**Addendum to Remedial Action Options Report (RAOR) and Pre-Design Sampling Work Plan - Connell Aluminum Properties, LLC  
Former Koppers Tar Plant and Wabash Alloys Site  
9100 S. 5<sup>th</sup> Avenue, Oak Creek, WI 53154  
BRRTS# 02-41-553761, FID#241379050  
Connell VPLE BRRTS #:06-41-560068**

March 13, 2020

**City of Oak Creek Utility Corridor Lot 1  
9170 South 5<sup>th</sup> Avenue, Oak Creek, WI 53154  
BRRTS#: 02-41-561425, FID #:341074470  
VPLE BRRTS#: 06-41-561426**

This Addendum letter addresses the WDNR's comment letter dated October 25, 2017 provided to Connell regarding *Review of Site Investigation and Remedial Action Options Reports, Former Koppers Tar Plant and Wabash Alloys Facility*. Reference is made in this letter report and/or on attached figures to the remedial actions proposed to be completed by Beazer East, Inc. including DNAPL tar removal, and barriers for PAH-contaminated soil using soil cover or potentially mobile tar capping using geomembrane.

**FIGURE 3**  
**FIGURE C41 (REV. SI REPORT)**

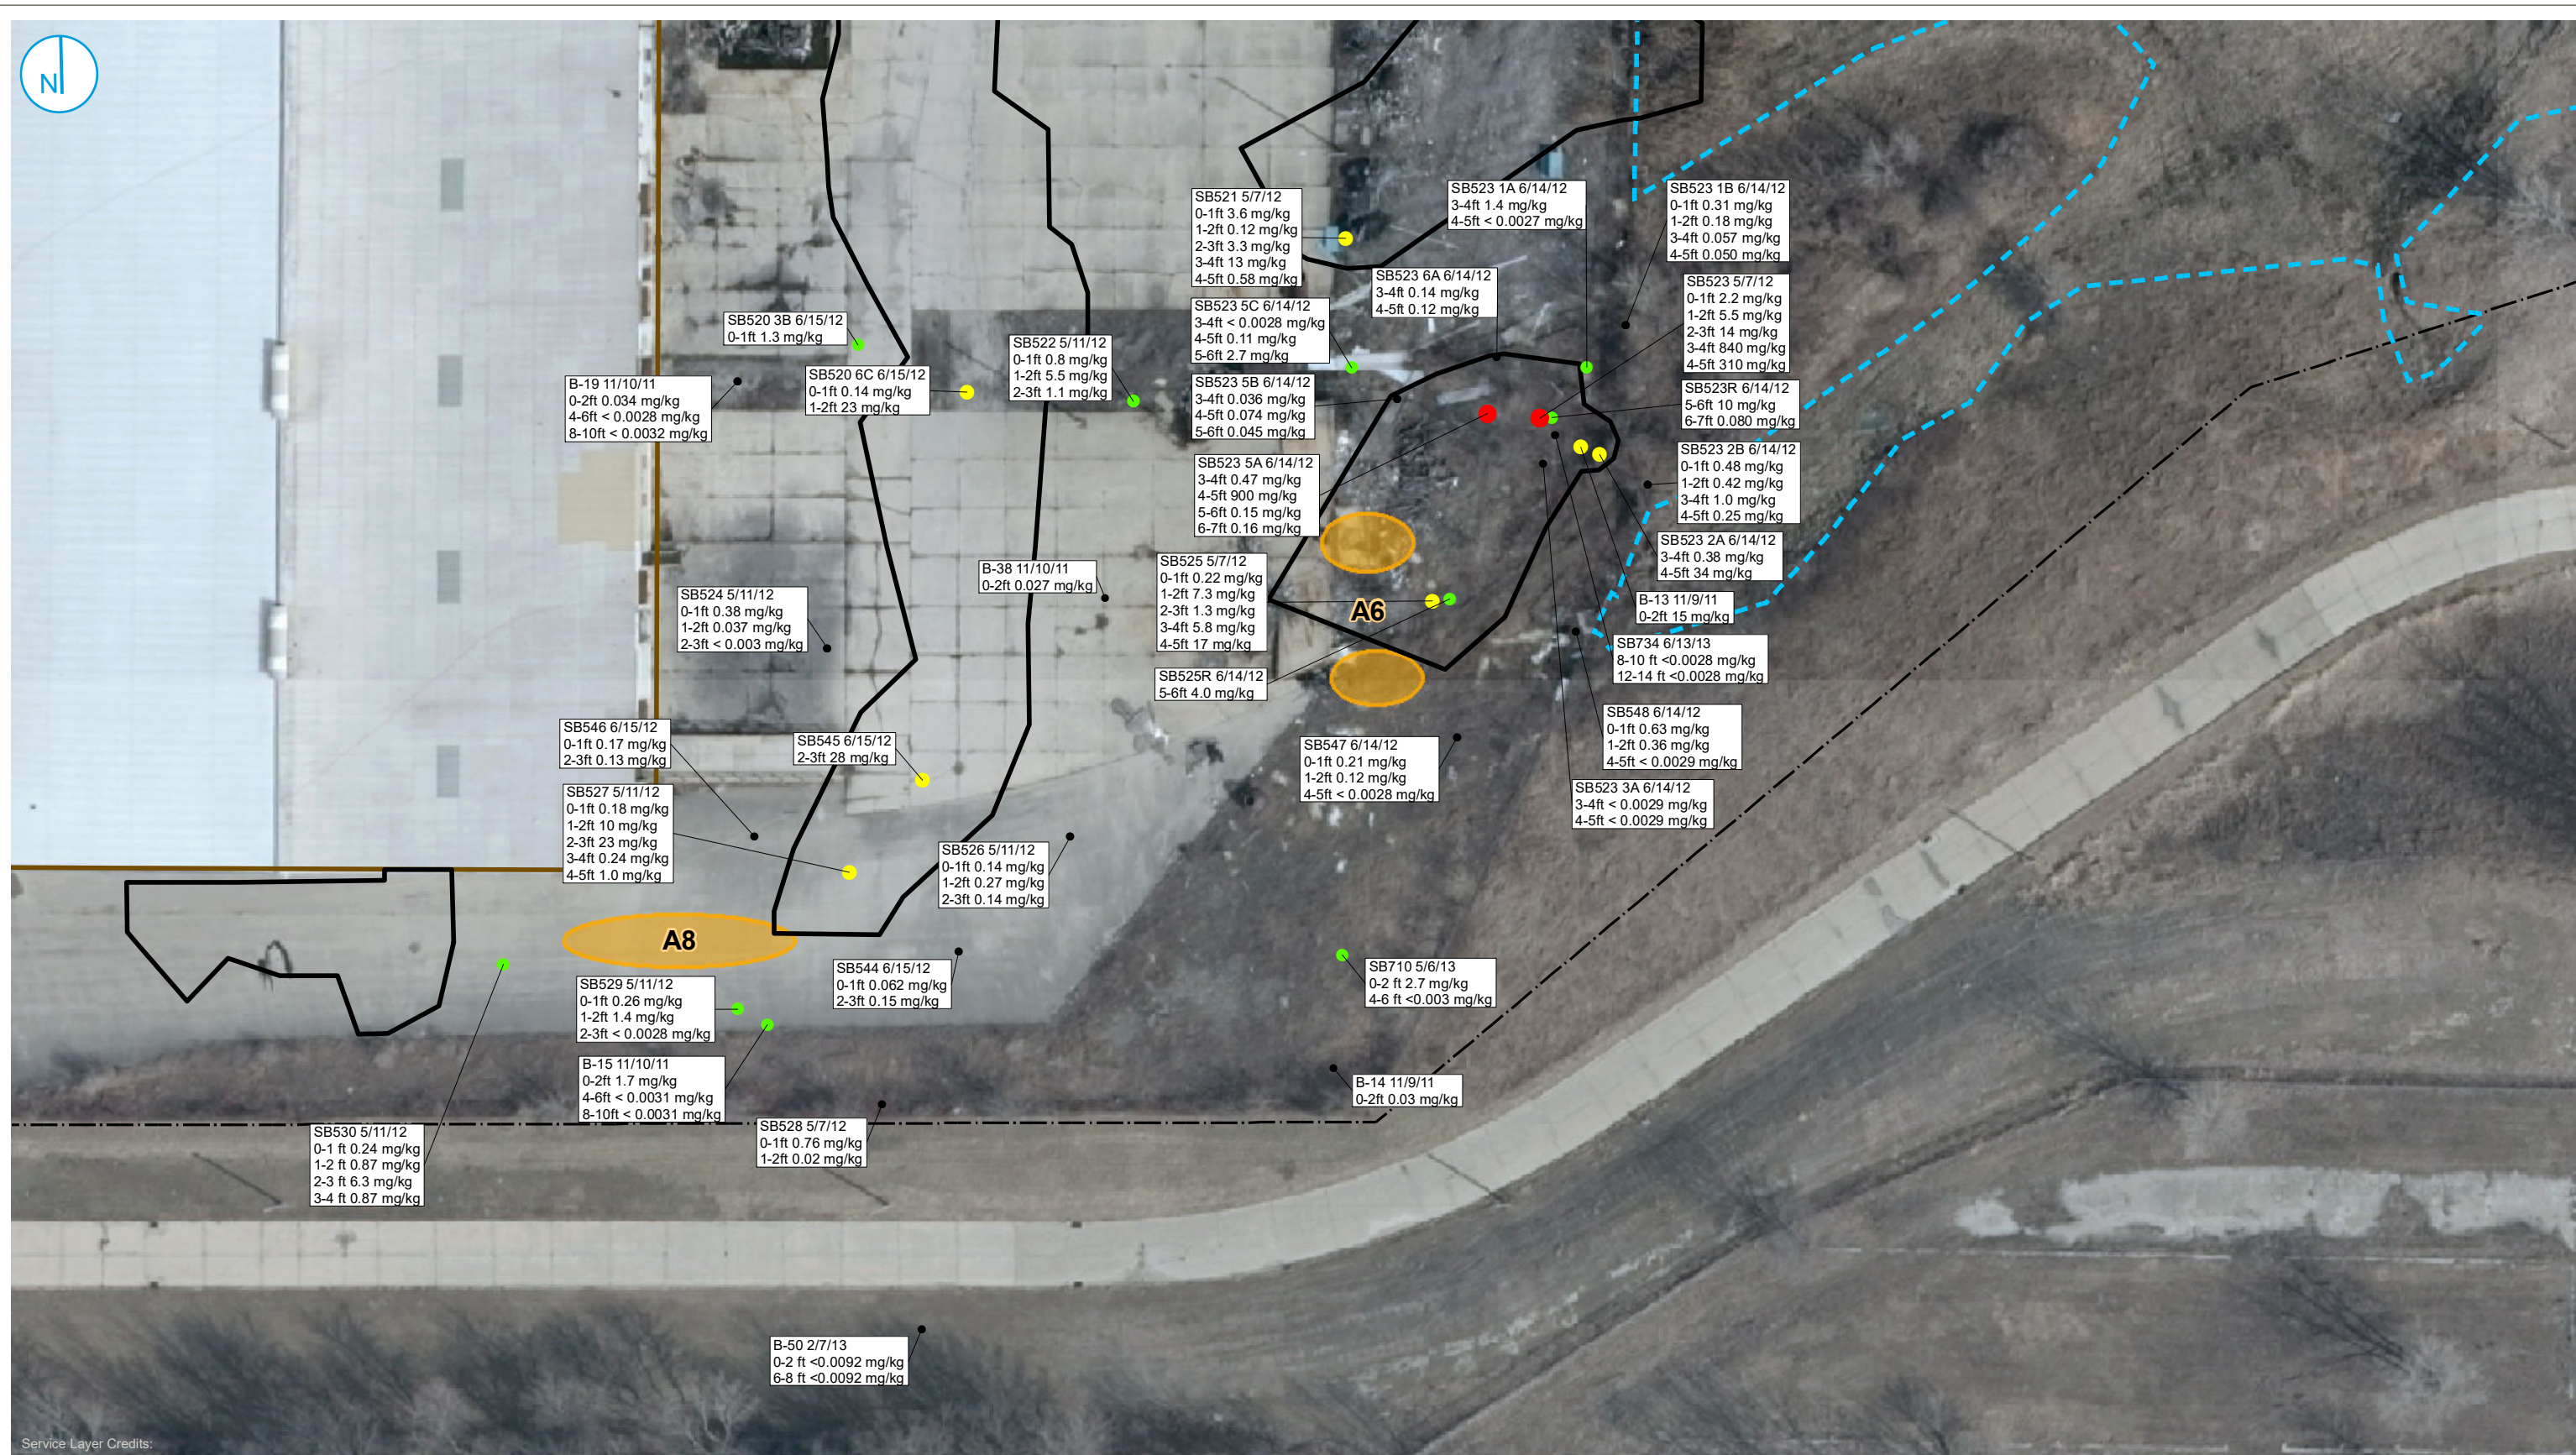
- Figure 3 – Revised Figure C41 SI Report – PCB Soil Data – South Yard TSCA Area for purposes of showing more specifically the additional PCB sampling locations related to comments A6 and A8.

**FIGURE 4  
FIGURE C42 (REV. SI REPORT)**

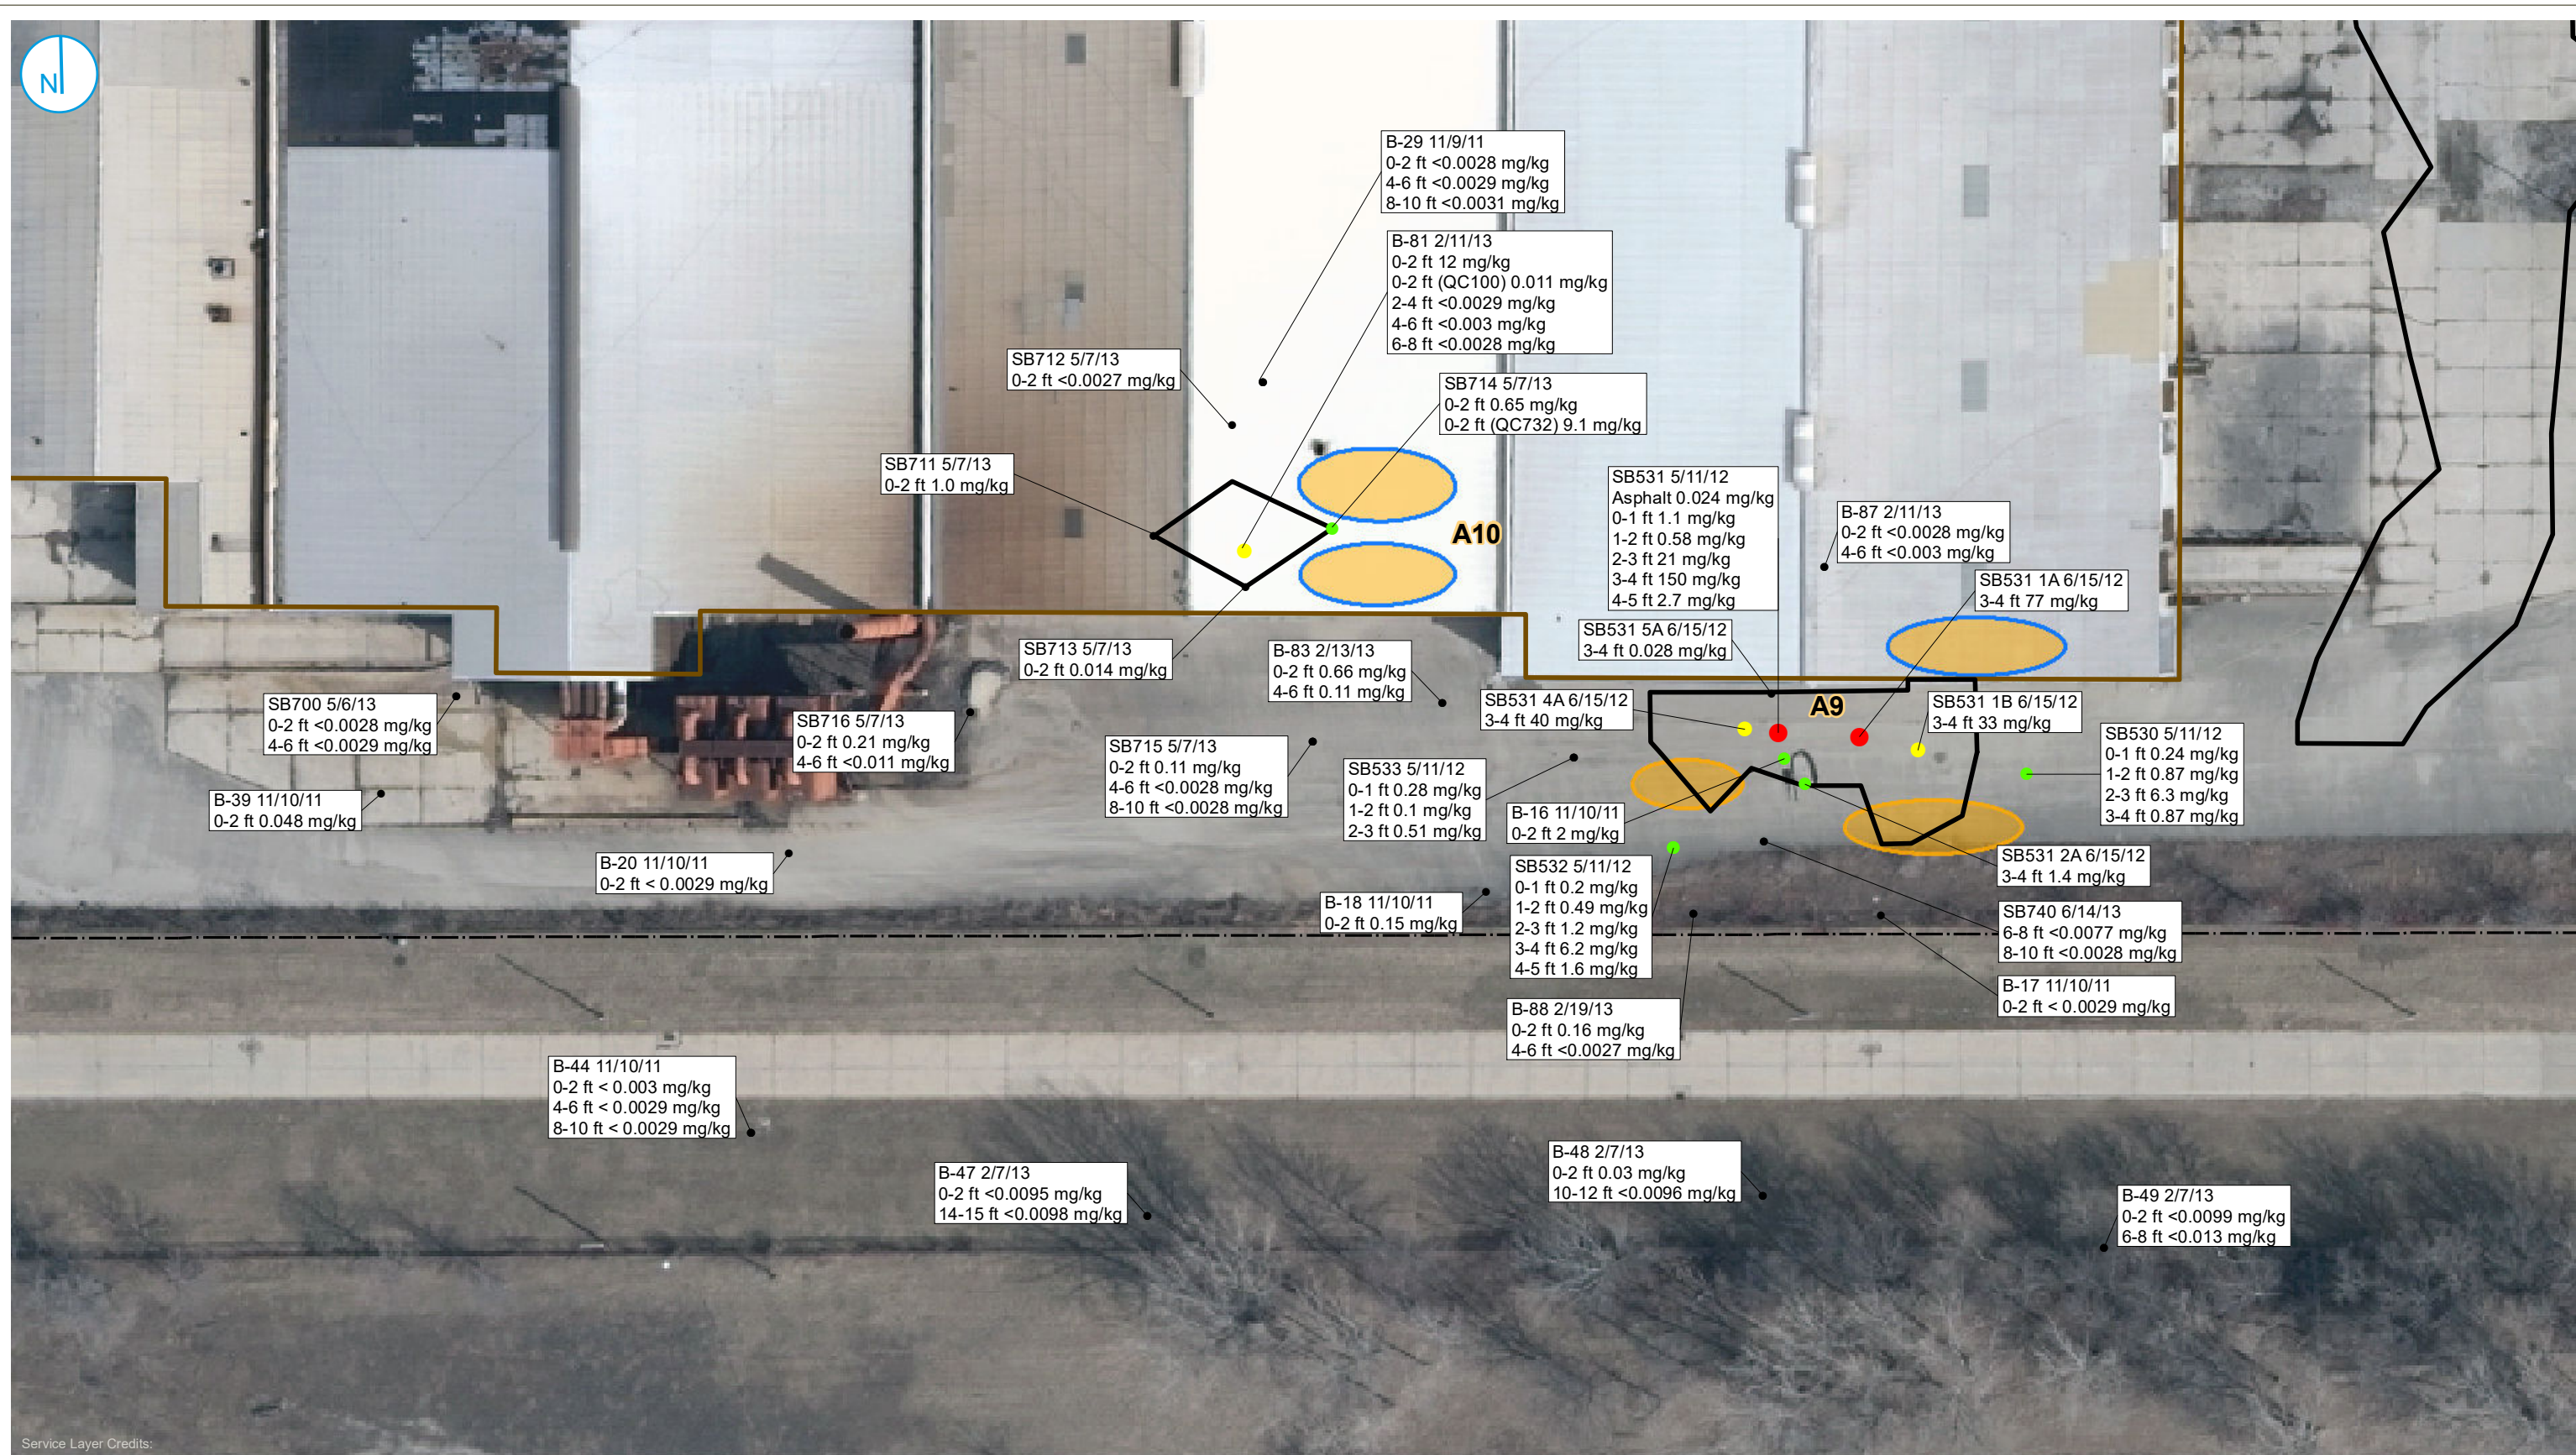
- Figure 4 – Revised Figure C42 SI Report – PCB Soil Data – South Exterior TSCA Area for purposes of showing more specifically the additional PCB sampling locations related to comments A9 and A10.
